ATTACHMENT 1

Proposed McGuire Unit 1 and 2 Technical Specification Changes

Figure 3.2-3 RCS FLOW RATE VERSUS R - FOUR LOOPS IN OPERATION

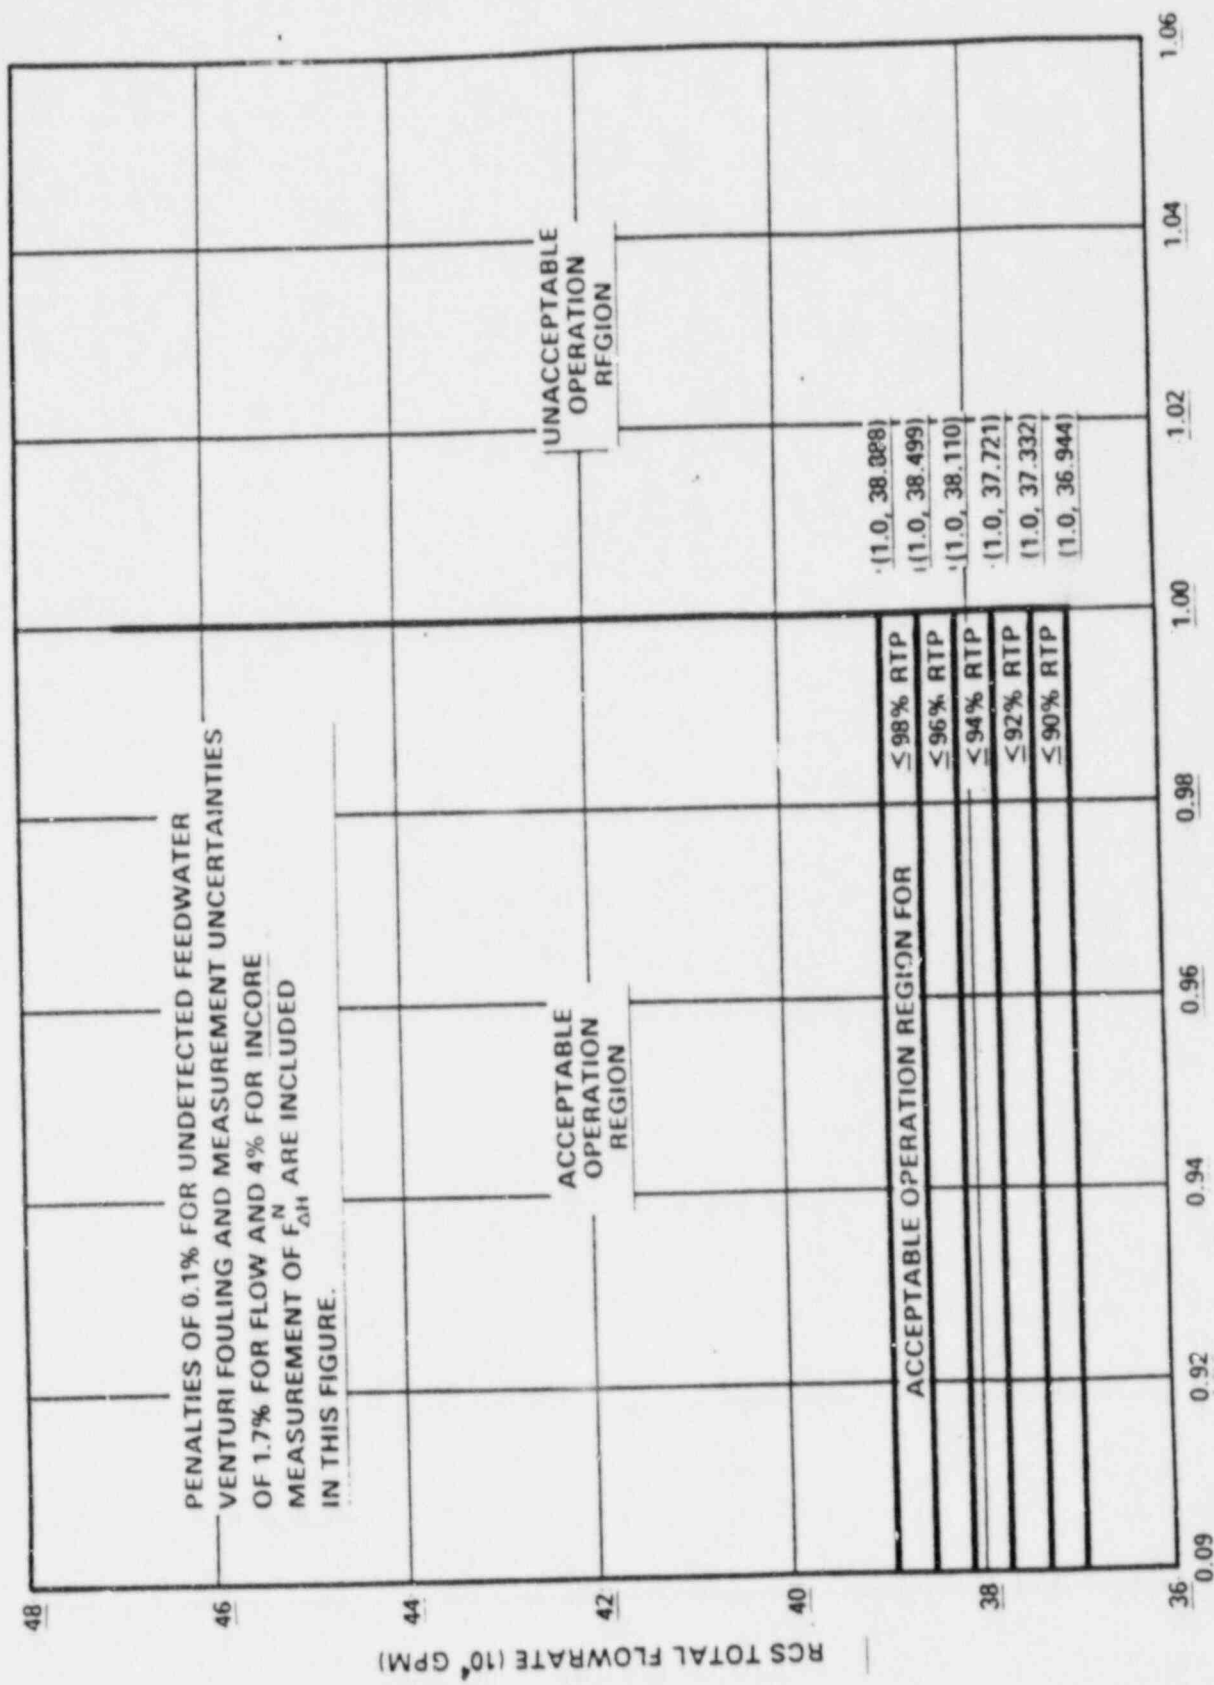
With the combination of RCS total flow rate and R outside the region of acceptable operation shown on Figure 3.2-3:

- a. Within 2 hours either:
  1. Restore the combination of RCS total flow rate and R to within the above limits, or
  2. Reduce THERMAL POWER to less than 50% of RATED THERMAL POWER and reduce the Power Range Neutron Flux - High Trip Setpoint to less than or equal to 55% of RATED THERMAL POWER within the next 4 hours.

- b. Within 24 hours of initially being outside the above limits, verify through incore flux mapping and RCS total flow rate comparison that the combination of R and RCS total flow rate are restored to within the above limits, or reduce THERMAL POWER to less than 5% of RATED THERMAL POWER within the next 2 hours. I

- c. Identify and correct the cause of the out-of-limit condition prior to increasing THERMAL POWER above the reduced THERMAL POWER limit required by ACTION a.2. and/or b. above; subsequent POWER OPERATION may proceed provided that the combination of R and indicated RCS total flow rate are demonstrated, through incore flux mapping and RCS total flow rate comparison, to be within the region of acceptable operation shown on Figure 3.2-3 prior to exceeding the following THERMAL POWER levels: I
  - 1. A nominal 50% of RATED THERMAL POWER,
  - 2. A nominal 75% of RATED THERMAL POWER, and I
  - 3. Within 24 hours of attaining greater than or equal to 95% of RATED THERMAL POWER. I
